HISTORIC AND DESIGN REVIEW COMMISSION

November 07, 2018

HDRC CASE NO: 2018-530
ADDRESS: 520 DAWSON ST
LEGAL DESCRIPTION: NCB 568 BLK 17 LOT W 41 FT OF 5
ZONING: RM-4 H
CITY COUNCIL DIST.: 2
DISTRICT: Dignowity Hill Historic District
APPLICANT: Gaspar Rivera
OWNER: Poma Properties LLC
TYPE OF WORK: General repairs; rear addition; window replacement
APPLICATION RECEIVED: October 08, 2018
60-DAY REVIEW: December 07, 2018
REQUEST:

The applicant is requesting a Certificate of Appropriateness for approval to:

Proposed Roof line

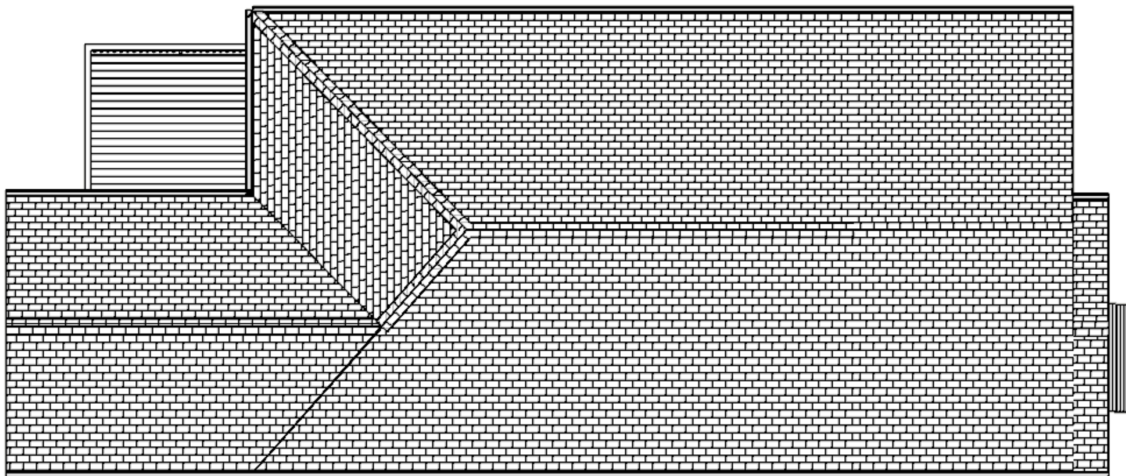
- d. ADDITION ROOF FORM - The applicant has proposed for the addition to feature a gable roof that is subordinate to the existing rear hipped roof. Staff finds the proposed roof form to be consistent with the Guidelines for Addition 1.A.iii noting that and addition's roof pitch, form, overhang, and orientation should be similar to the historic structure.

Proposed Elevations

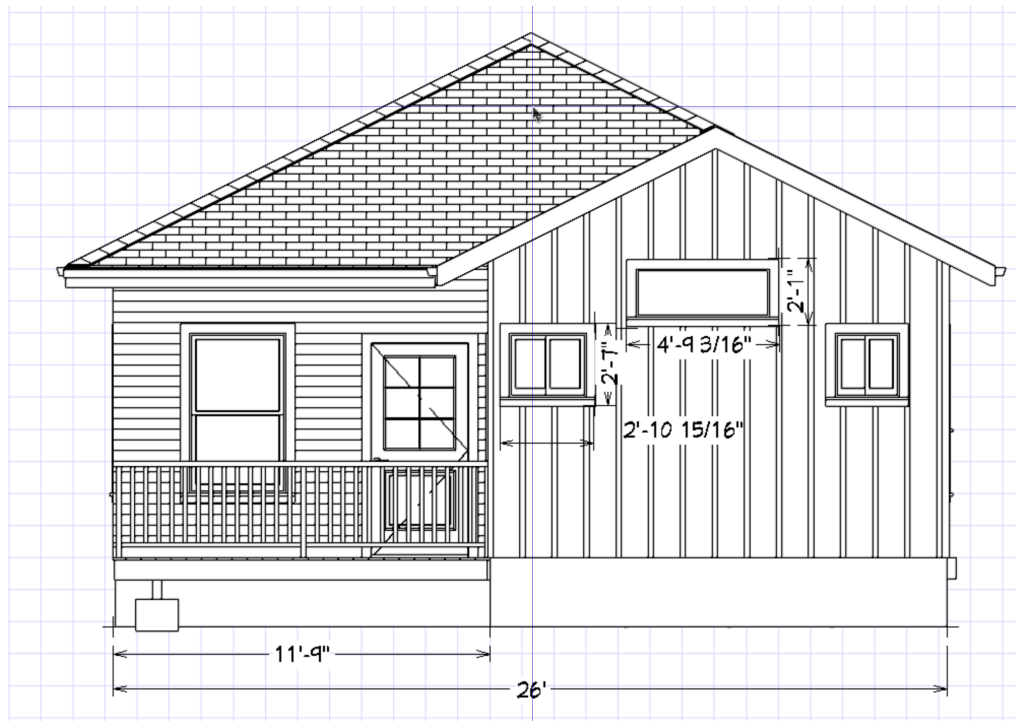
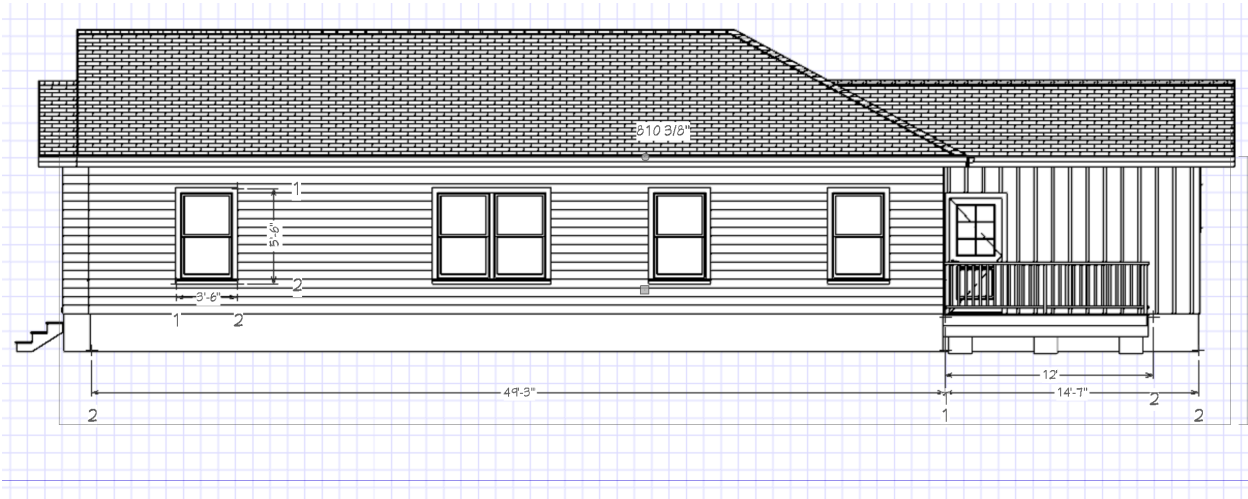
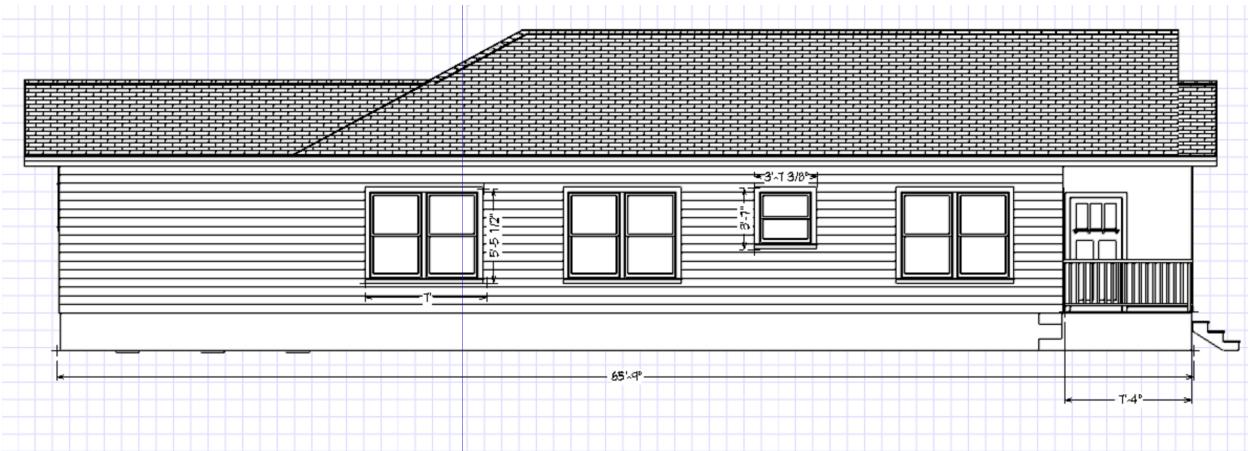
- b. REAR ADDITION – The Guidelines for Additions 1.A. states that additions should be sited to minimize visual impact from the public right of way, should be designed to be in keeping with the historic context of the block, should utilize a similar roof form and should feature a transition between the old and the new. The applicant has proposed for the addition to feature a new wall plane that is flush with the existing wall and a subordinate gable roof that meets the existing hipped roof. Staff finds that the proposed addition and its details are not visible from the right of way and is generally consistent with the Guidelines, with the exception to exclude a subordinate ridge line and/or inset wall plane.

- e. ADDITION TRANSITION – The applicant has proposed to use a board-and-batten siding to distinguish between the original lap siding structure and the new addition. Per the Guidelines for Additions 1.A.iv, additions should feature a setback or recessed area and a small change in detailing at the seam of the historic structure and new addition to provide a clear visual distinction between old and new building forms. A vertical trim piece may also be used to differentiate the proposed addition from the new construction; however, it should be installed in addition to the use of a subordinate ridge line and/or inset wall plane.

- g. ADDITION WINDOWS - The applicant has proposed to install a horizontal picture window flanked by two slider windows on the rear façade, and a double hung window on the east elevation. The applicant has noted that the window materials will be vinyl. Staff finds that the window configurations and locations are generally appropriate as they are not visible from the public right-of-way. However, staff finds that windows should feature wood or aluminum-clad wood as opposed vinyl per the Guidelines for Additions 3.A.i noting that new materials introduced to the site as a result of an addition must be compatible with the architectural style and materials of the original structure.

- i. That the addition features an inset wall plane in addition to the proposed subordinate roof form.
- ii. That the addition features wood or aluminum-clad wood windows as opposed to the proposed vinyl windows.
